RE: Proposed Ground Water Investigation and Well Installation Addendum

Simpson Property 489 43rd Street Oakland, California WA Job No. 138-1231-02

Soil Boring Location - 489 43rd Street, Oakland, California Figure 2

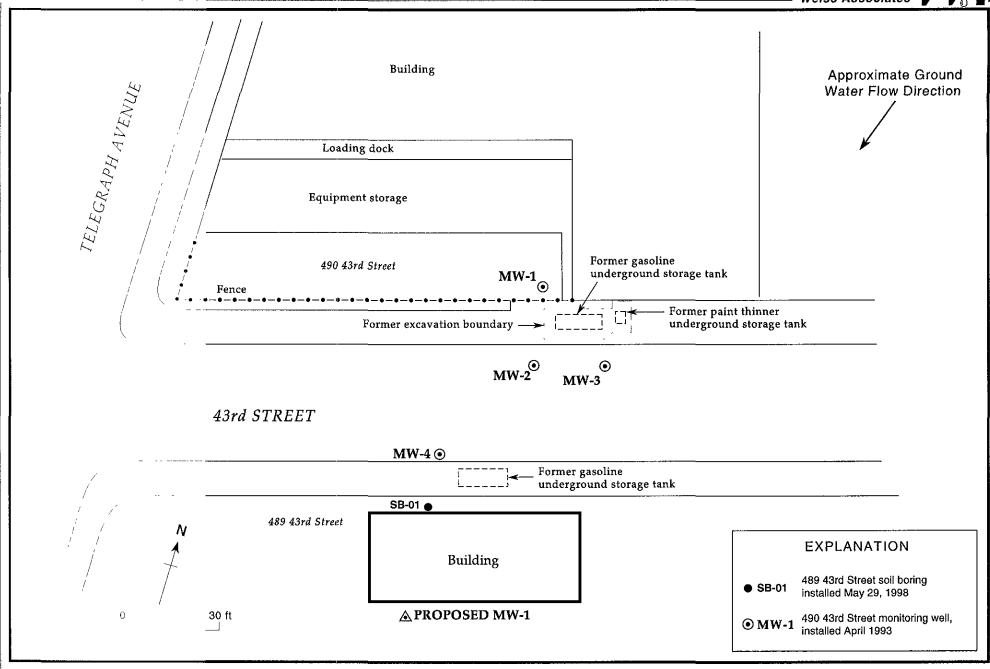
In response to your letter dated September 14, 1999, Weiss Associates (WA) is submitting a revised Figure 2 - Soil Boring Location (enclosed). Although the text of our September 1 workplan stated, "The proposed well location is in the courtyard of the subject site," this information was not clearly indicated in our original figure due to the lack of the building footprint. WA will include the building footprint in future figures as requested. As requested, WA will also run the dissolved oxygen and oxidation-reduction potential parameters on each ground water sample prior to collecting the sample from the well.
